City of Richmond
Urban Development Division

Report to Committee

To: Planning Committee
From: Holger Burke
Acting Director of Development
Date: October 3, 2005
File: RZ 04-272331
Re: **Application by Sungrand Development Ltd. for Rezoning at 11651 / 11671 / 11691 / 11711 Steveston Hwy. from Single-Family Housing District, Subdivision Area E (R1/E) to Townhouse District (R2-0.6)**

RZ 04-272331

| Attachment 2: | Conceptual Site Plan and Elevations |

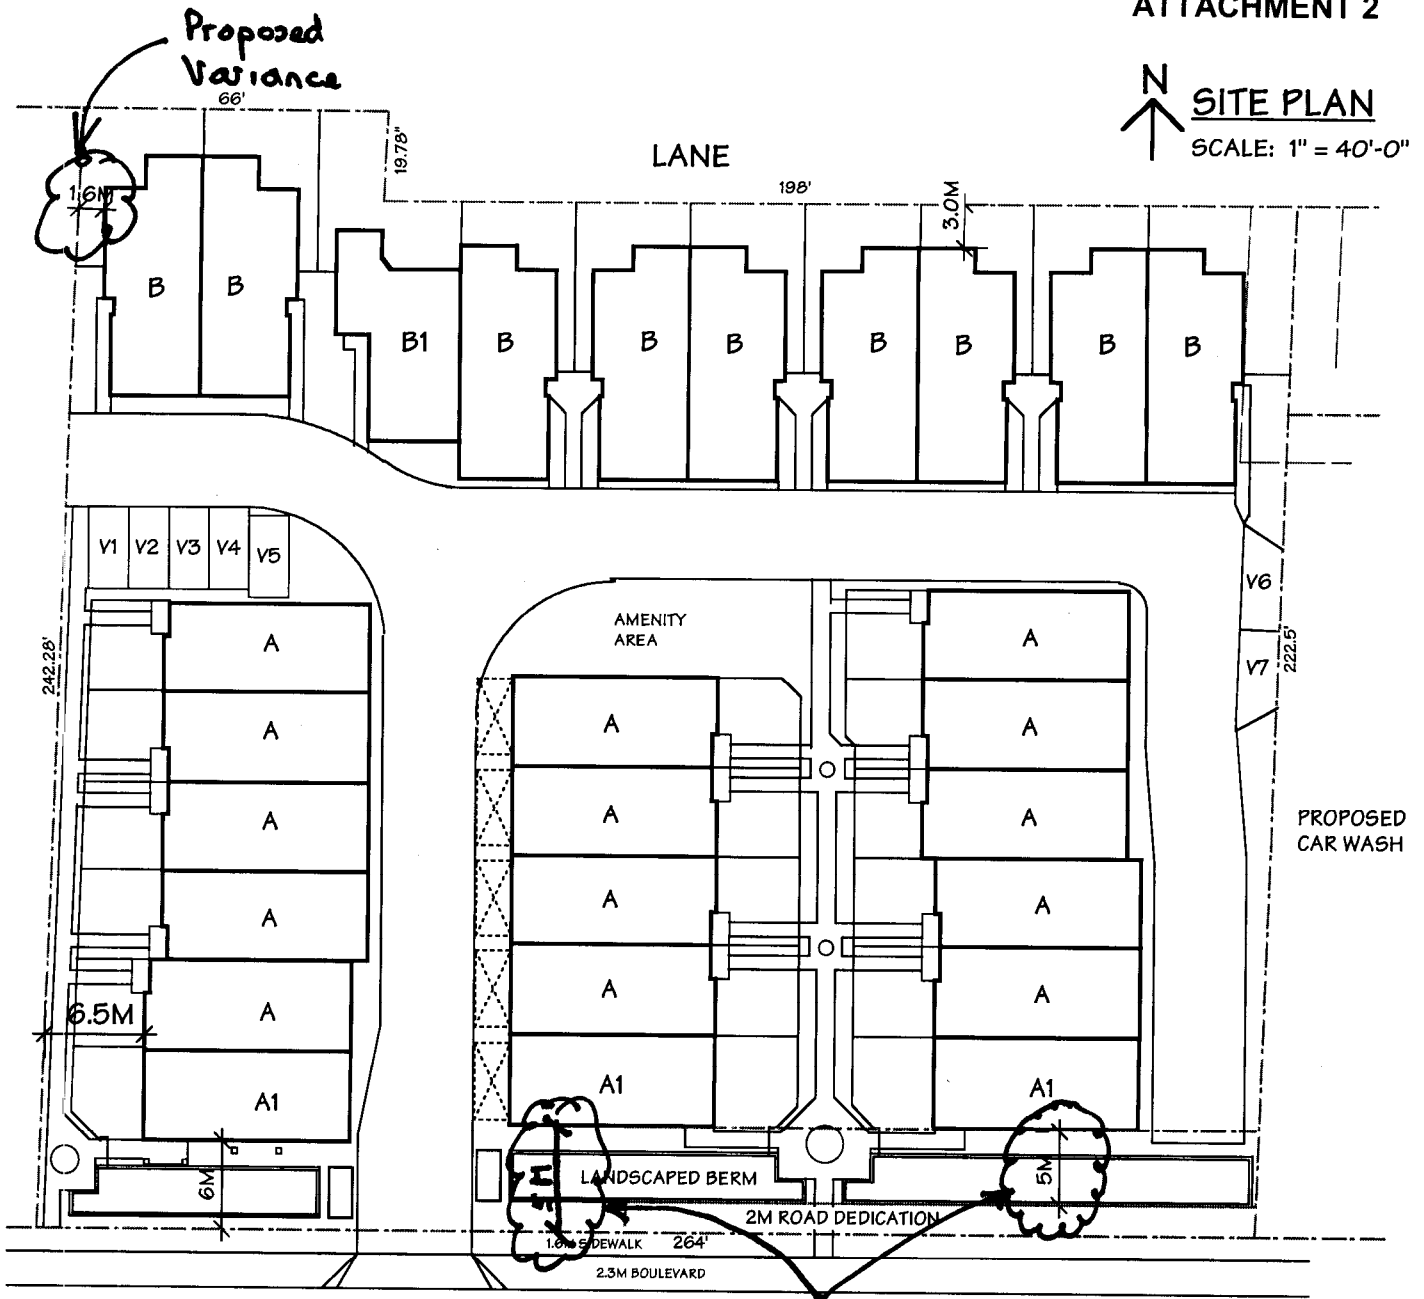
Comments on the site plan dated Sept 14, 2005:

1. Require land dedication of 2-m width along the site's south frontage along Steveston Hwy. from the site's eastern property line to approximately 42 m west of the site's eastern property line.

2. Frontage improvements (including sidewalk, grass-treed Boulevard) are required along the site's Steveston Hwy. frontage.
3. Register on title a 7.5m wide Public Right-Of-Passage (PROP) Right Of Way (ROW) from Steveston Hwy., that tapers at a 5:1 ratio starting at 5m from the site's southern property line along Steveston Hwy, getting down to a 6m PROP at the interior intersection. A 6m wide PROP is also required for the East-West portion of the internal roadway that runs between the interior intersection and the western property line.

4. The entrance driveway is to be 7.5-m wide for a minimum length of 5 m measured from the southern property line into the site. The paved area dimensions should conform to the PROP noted above.

5. Conform to City's Parking Bylaw on the number and dimensions of the off-street parking. Development Permit plans should indicate the parking stall dimensions on a scaled drawing. One handicapped parking stall is required.
6. For the Development Permit, demonstrate how a loading truck (i.e., SU-9) could be accommodated on site. Show vehicle turning paths on a scaled drawing.
7. Prior to issuance of a Building Permit, a construction parking and traffic management plan is to be provided to the Transportation Department to include: location for parking for services, deliveries, workers, loading, application for request for any lane closures (including dates, times, and duration), and proper construction traffic controls as per Traffic Control Manual for Works on Roadways (by Ministry of Transportation) and MMCD Traffic Regulation Section 01570.

There is insufficient info to provide detailed urban design comments. The applicant is advised that the following concerns arise from the site plan and should be addressed in the Development Permit application in addition to design issues:

- Revise site plan to conform to required setbacks and provide required accessible parking space.
- Most of the existing trees are proposed to be removed. All of the perimeter trees and the tree located in the pedestrian street should be considered for retention if viable. To this end, remove V6 as only 6 visitor parking spaces are required.
- There is a missed opportunity to provide back yards for the West units. Careful design will be needed to address CPTED issues and form and character of the proposed narrow pedestrian connection. Consider orienting pedestrian front entries to much more visible and prominent manoeuvring aisle.
- Improve views into and within development.
- Locations and details are required for recycling, garbage, mailbox and servicing closets/rooms.
